API REVIEW

API's Review of Recent USGS Pavillion, Wyoming Reports Show USGS Groundwater Sampling Results Differ From EPA's Results in 2011 Draft Report

Figure 1. Modified after USGS Figure 2, Data Series 718 Report ¹

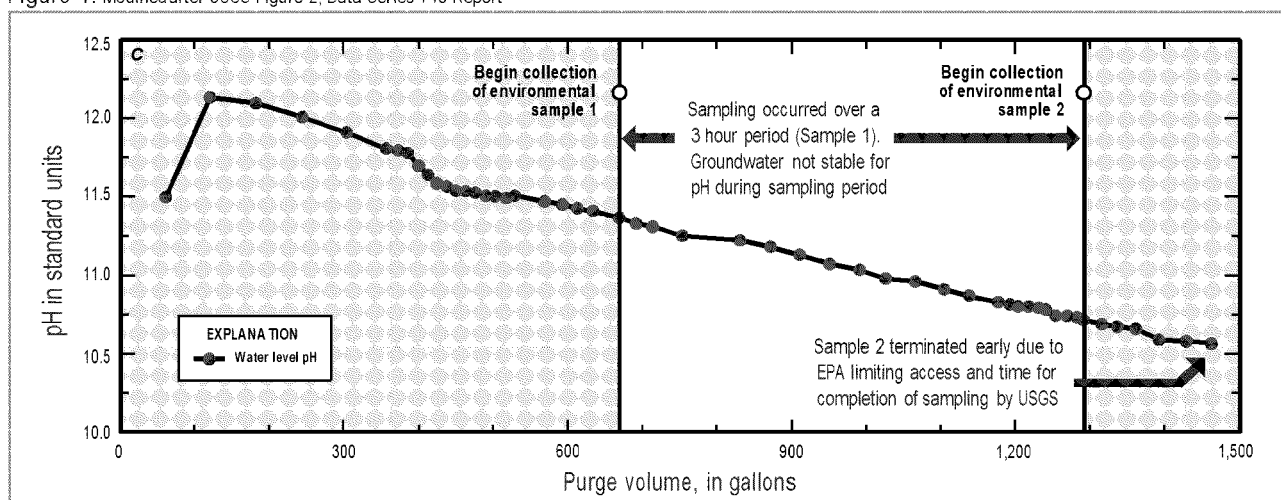
- USGS' SAP² specified a criterion for sampling that required the pH of the groundwater to be stable for sampling. A review of the USGS data presented in the report¹ shows, as depicted in Figure 1, pH stabilization did not occur during sampling, and the graph suggests that well MW-01 is likely still being impacted by high pH cement and/or drilling fluids used during monitoring well drilling or construction.
